# UNITED STATES PATENT AND TRADEMARK OFFICE

10/588,387

<b>Office Action Summary</b>	<b>Application No.</b> 10/588,387	<b>Applicant(s)</b> ZENOBI, MAURO	
	<b>Examiner</b> Daniel C. Comings	<b>Art Unit</b> 3744

## **DETAILED ACTION**

Fig. 1

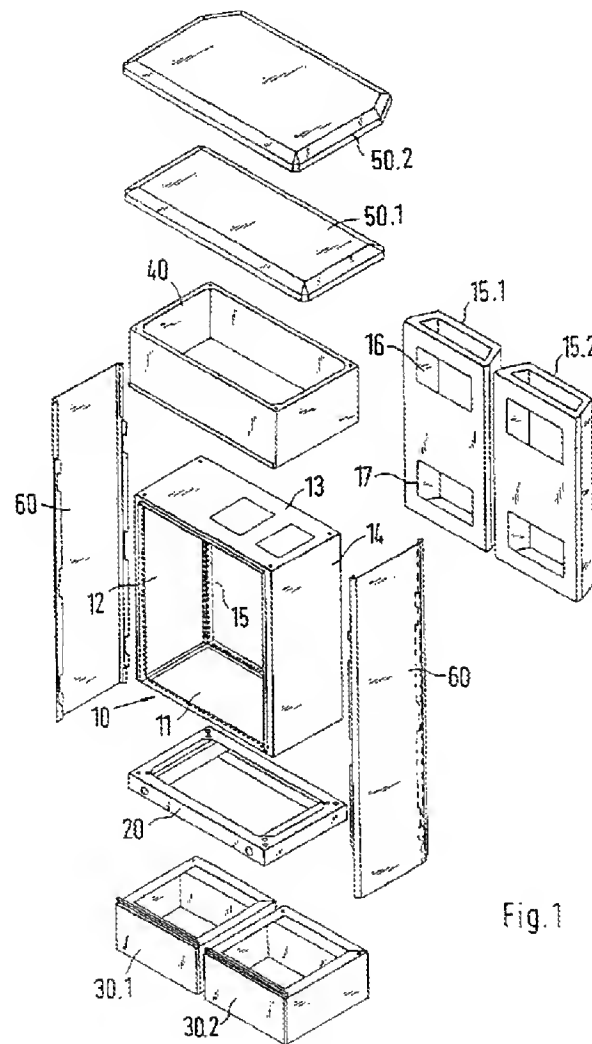
Scheuer does not teach the presence of a separate compartment for the cooling and processing systems. The inclusion of a separate compartment in a refrigeration device is well known in the art as illustrated by Strackbein. Strackbein teaches in fig. 1 shown on pg. 9 of this action, a modular housing for a refrigeration device having refrigeration components (15.3) (embodied as an air conditioner) arranged in compartments separate from the compartment to be refrigerated (within body 10) and also an additional air conditioner 40.1 (not shown in fig. 1) in the separate roof housing (40). It would have been obvious to one of ordinary skill in the art at the time the invention was made to modify Scheuer with the separate machinery compartment of

Strackbein and further to place the processing system within that compartment because the placement of heat generating components outside of the refrigerated space allows the temperature in the refrigerated space to be controlled more easily thus raising the efficiency of the system.

**Fig. 2x**

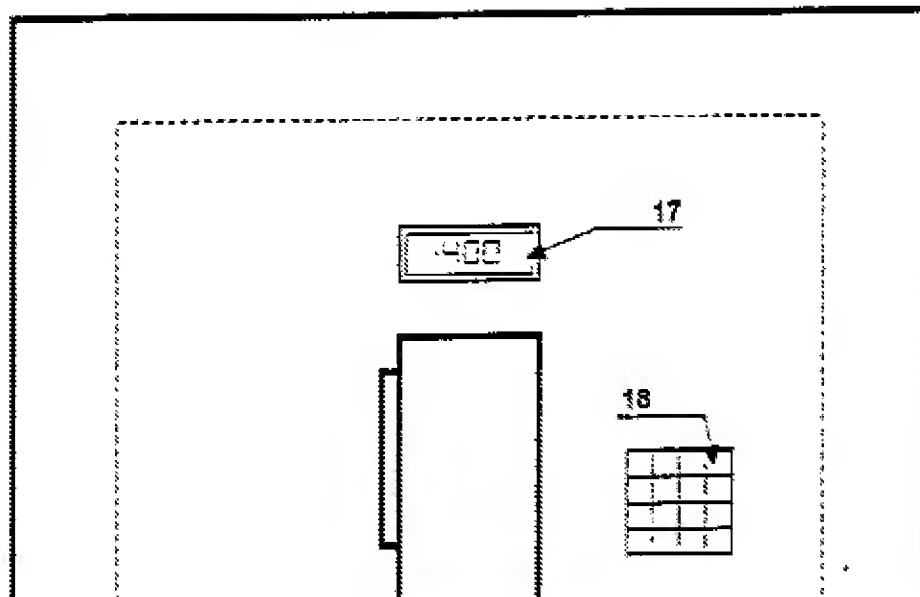
Scheuer teaches limitations from claim 13, an apparatus according to claim 12 wherein the processing system is capable of controlling the receiving, preservation and supply (Scheuer's invention is taught for receiving, preserving (by cooling) and dispensing units of blood in the Abstract) of the bags and is connected to a keyboard (in the last paragraph of pg. 1) and a screen (in the first paragraph of pg. 1), both placed at the walls of the cabinet (as shown above in fig. 2x, a section of Scheuer's fig. 2, enlarged by examiner.)

Fig. 3

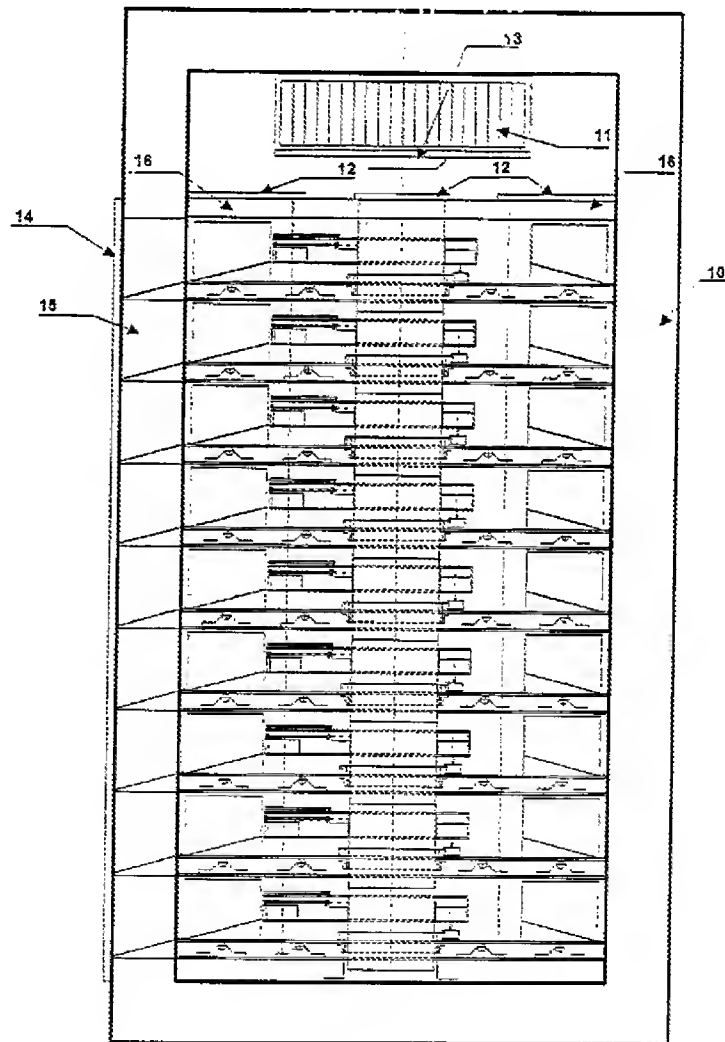
Scheuer teaches limitations from claim 17 in fig. 3, shown above, an apparatus according to claim 12 comprising only one door (14) which extends from the first to the last level of the magazine (as shown) and wherein the movement system is capable of rotating a single level at a time (Scheuer teaches in the second paragraph of pg. 3 that the turntables are capable of turning in different directions from one another, thus implicitly teaching that they can be independently controlled.)

Regarding the teaching of one cell on each level being notional, Scheuer does not teach the presence of such notional cells. One of ordinary skill in the art would have found it to be an obvious mechanical expedient to provide the system with such notional cells in which blood units are not stored and thus provide space for additional equipment, for example sensors for individually monitoring each of the levels to provide more accurate and efficient temperature control.

Fig. 1

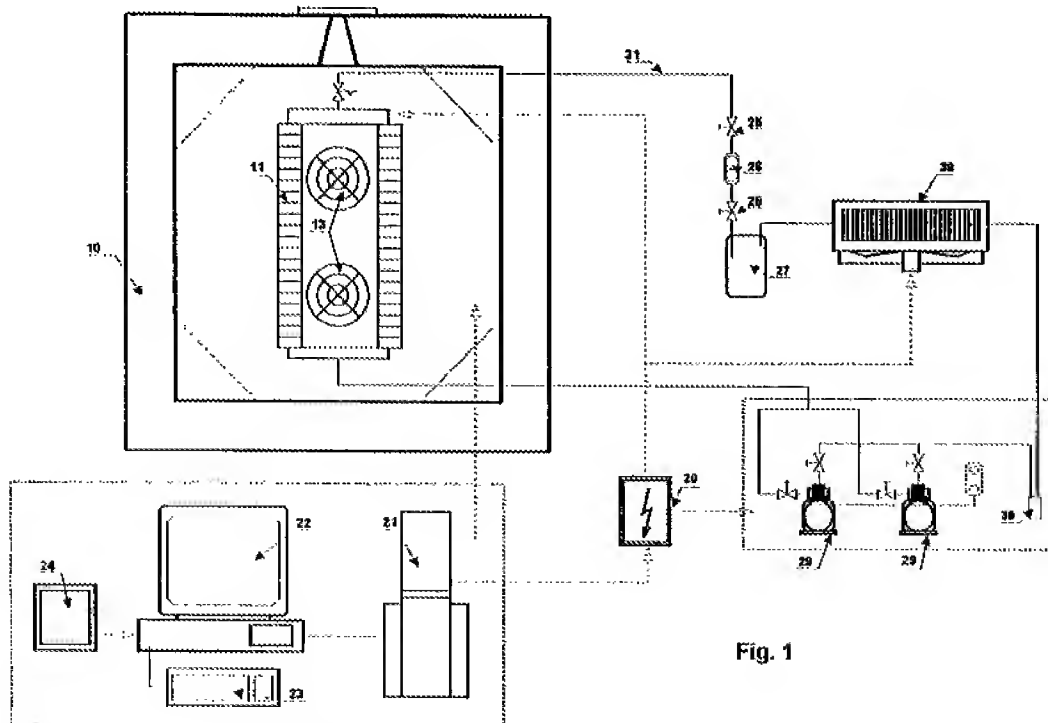
Scheuer teaches limitations from claim 18, an apparatus according to claim 12 wherein the processing system comprises a sub-system for thermal control of the refrigerated space (teaches a programmable controller for the cooling system being located in cabinet 20 in fig. 1, shown above, in the second to last paragraph on pg. 3), said sub-system being independent of, but in communication with, the processing system (the cabinet 20 is shown to be in communication with the computer at 22 but no control by the computer is disclosed.)

FIG. 6c

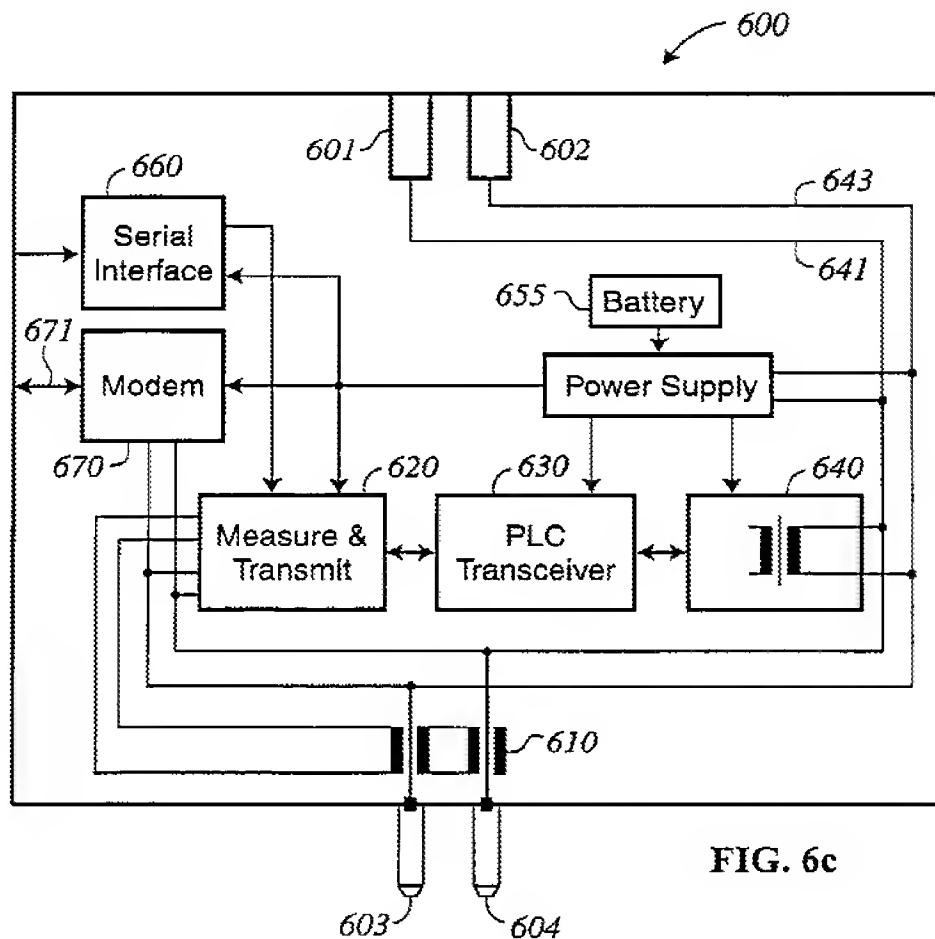
Regarding claims 15 and 16, Scheuer does not teach the system having a wireless network port or wireless modem. The use of such wireless connection components is well known in the art as illustrated by Sharood. Sharood teaches in fig. 6c, shown above, a system for remotely monitoring a refrigeration system, the monitoring system having a modem (670) taught in lines 40-45 of col. 10 to optionally be wireless. One of ordinary skill in the art at the time the invention was made would

recognize that the modem would also serve as a port for connecting the device to a computer network (such as via a telephone connection) and that thus this modem satisfies the limitations of both claims 15 and 16. It would have been obvious to one of ordinary skill in the art at the time the invention was made to modify Scheuer with the modem of Sharood in order to allow for remote control and monitoring of the refrigeration system thus greatly increasing the convenience and usefulness of the system.
